N1092C-02

Modification Available Performance Enhancement Service Note

N1092C DCA-M Sampling Oscilloscope

An improved extinction ratio calibration is available for DCA-M Sampling Oscilloscopes with option 30A

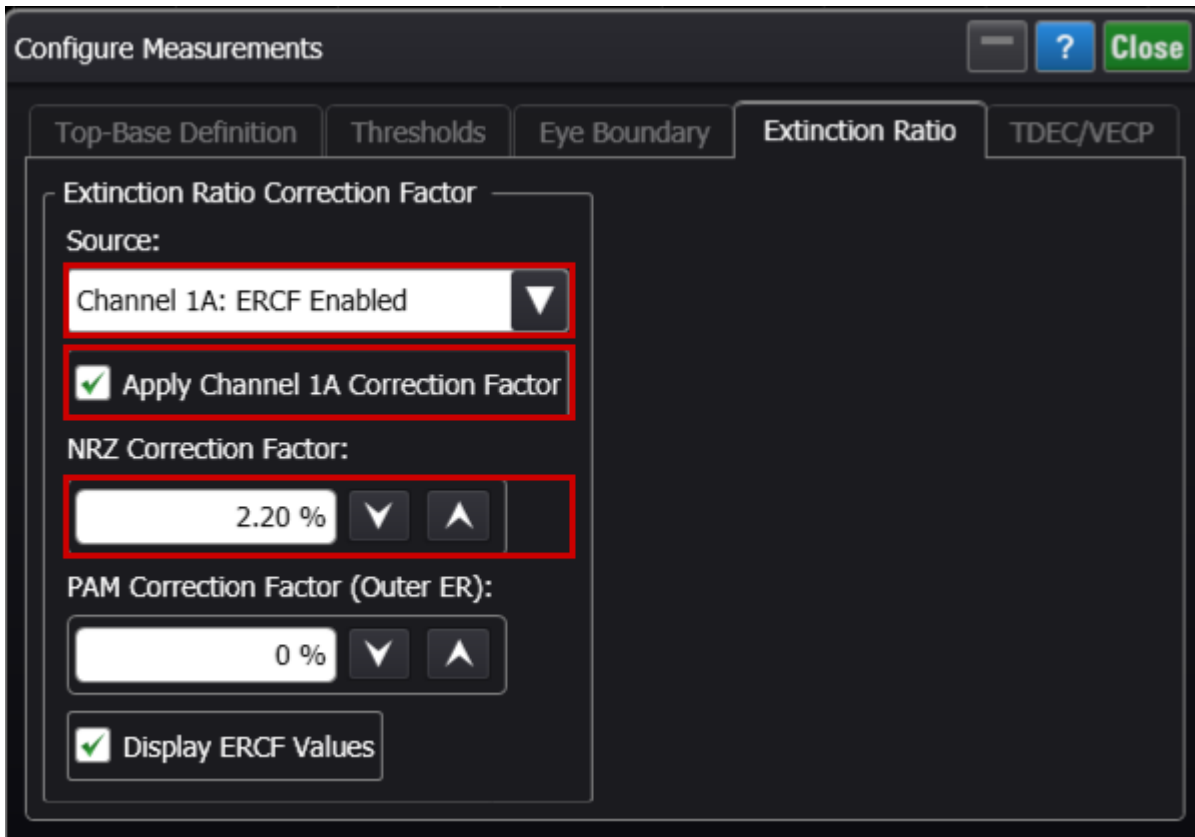
For N1092x DCA-M instruments with option 30A, units with the improved ER calibration are identified in the Help > About dialog with a “C1” annotation following the serial number.

- If the “C1” annotation is present, the unit has the improved ER calibration
- If the “C1” annotation is not present, the unit has the older ER calibration
